Standard VGA Cable Pinout

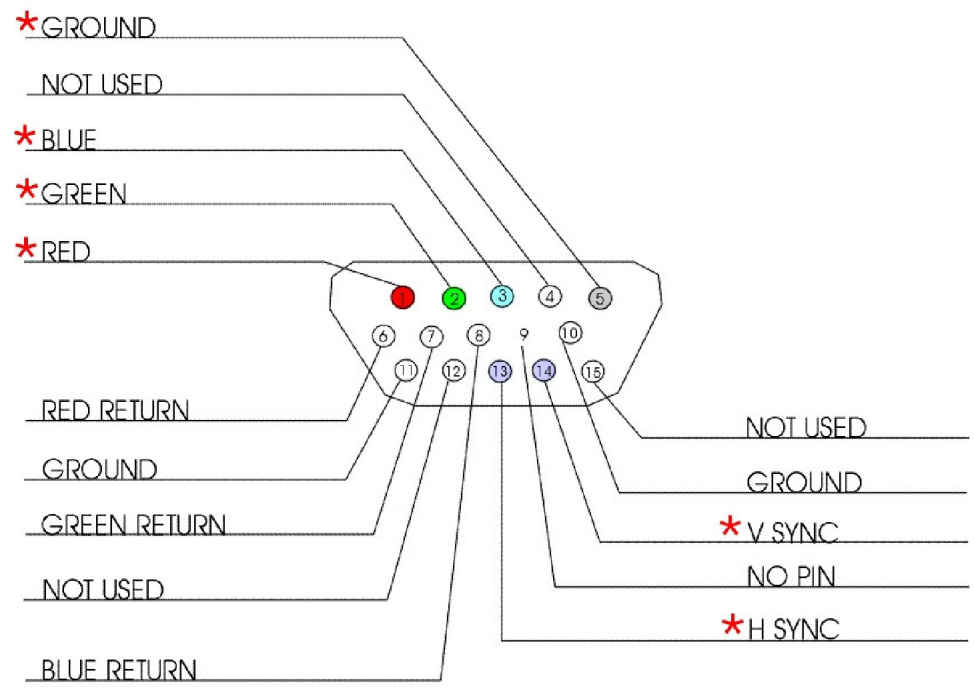
LOOK AT THESE THINGS IF THIS MOVES TO A REAL PCB FOR PRODUCTION
AVDD and DVDD pins should each have their own filtered 1.8V
According to spec sheet we should have separate AGND and DGND but demo board didn't have them separate
Unused pins are recommended to be tied to a certain potential
Test board has all DVDD/AVDDs tied to 1.8V but nominal is 1.9V
Attach PLL voltages to separate 1.8V supply
